Dear reviewer and dear Editor,

In the following we report the answers to the reviewer comments as well as some clarifications about some choices done in the work. We thank the reviewer because we believe that some suggestions can improve the paper. Various comments request to make modifications on manuscript (figures, table, text modifications...), in the answers in some cases we discuss how we propose to modify the text and we give some anticipation about the possible improvements; if editor and reviewer will think that we can proceed with the review process then we will implement these modifications in the manuscript and submit a new version.

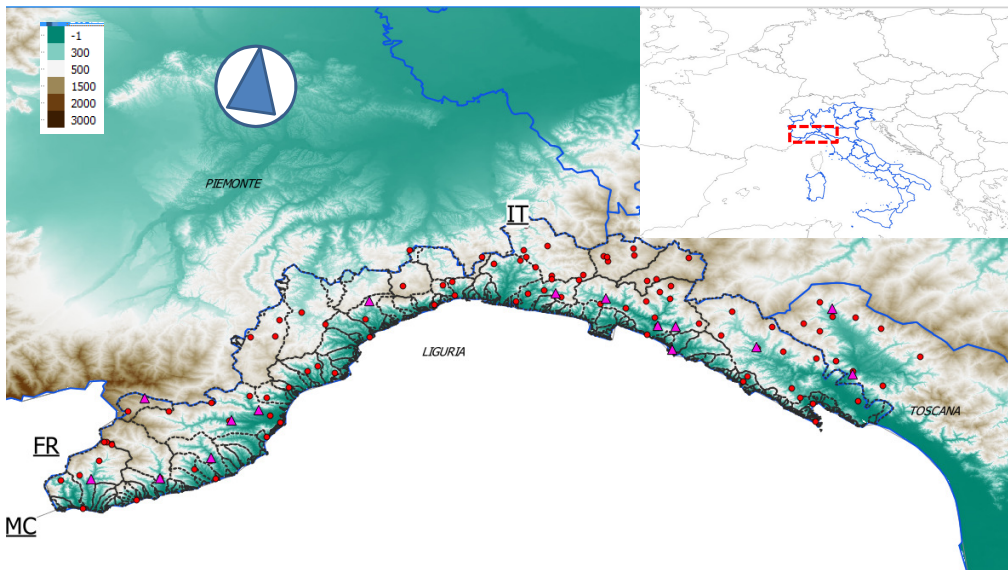
- Figure 1: Add to the figure a North Arrow, scale bar, color bar for topography and its source. I would zoom in to the area of interest and add an inset plot showing the regional location of the study site within Europe.

*We will modify the figure as requested in the new version, follows a new version of the figure (we will modify the caption in the text):*

Figure 1: Number of days with heavy precipitation (>10 mm) for the period 1979–98 (modified from Pieri et al. 2015).

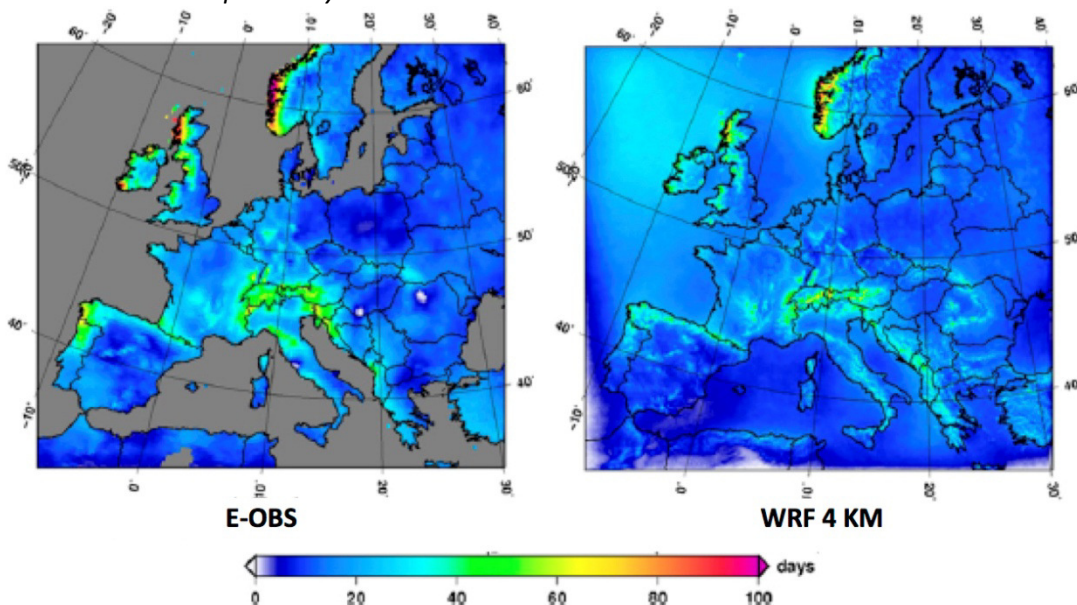
Page 14, line 12-17: do this analysis at a basin-scale as that's the relevant scale of the study. I'm not convinced about that EXPRESS-Hydro "reproduces quite well" the observed precipitation. Need further analysis. How are the extreme precipitation events represented by the reanalysis? This is critical to properly represent peakflows. What about temperature?

*Concerning the other questions, Pieri et al. (2015) assessed the EXPRESS-HYDRO results capability to correctly reproduce the statistics of intense precipitation events both over Europe CORDEX domain at large and over the Great Alpine Region (GAR). The following figure shows the map of the number of days with rainfall rate larger than 10 mm for E-OBS and for EXPRESS-HYDRO runs. According to E-OBS, frequent heavy precipitation days are essentially localized over the Alps, western Norway, Scotland, and Portugal. This spatial distribution is well captured by EXPRESS-HYDRO runs.*

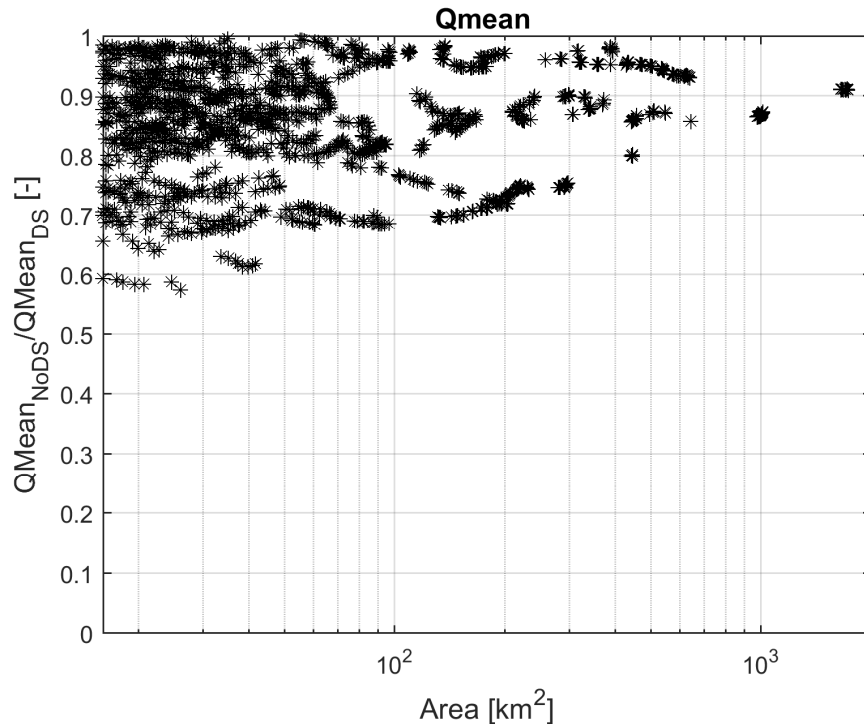
Can you evaluate the performance of the spatio-temporal downscaling?, this seems rather critical when assessing peakflow that may be generated from intense hourly rainfall-runoff events.

To assess the impact of downscaling we made the hydrological simulation with BC rainfall but **without** applying the downscaling, we estimated the ratio of  $Q_{mean}$  (mean of 30 years ADM) without and with Downscaling for each pixel.

Results are plot versus drainage area (see figure below). It is quite evident the impact of downscaling, the impact generally increases when drainage area decreases. This graph also help to answer to one of the comment below regarding the underestimation of quantiles for very small basins: the downscaling is crucial to face this issue but probably the adopted configuration is not sufficient when drainage area drops below certain values.

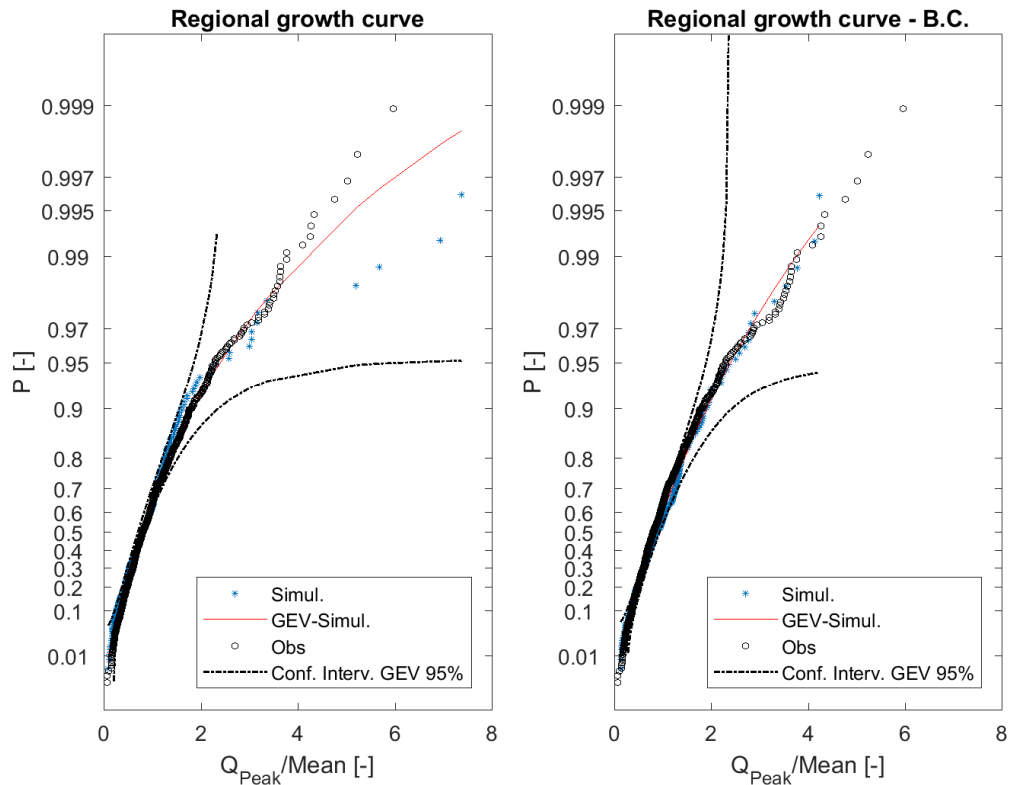
- I think you need to show that the model works well representing ADM at a basin-scale to perform the regional analysis. So far, the simulations at only 9 basins pass the statistical test (out of 15 from fig 12), but then the regional analysis is performed using all of them? Are those basins without streamflow records also included? (they should not). The relatively good agreement from the regional frequency distribution function analysis (fig 13) could be due to a compensatory effect.

*If the reviewer and editor agree we propose to show also the regional curve obtained using only the 9 basins which passes the test. This comparison could help to show the possible differences. The following figure is generated using time series from the 9 basins which pass the KS test, the fit is good as the one shown in the paper.*
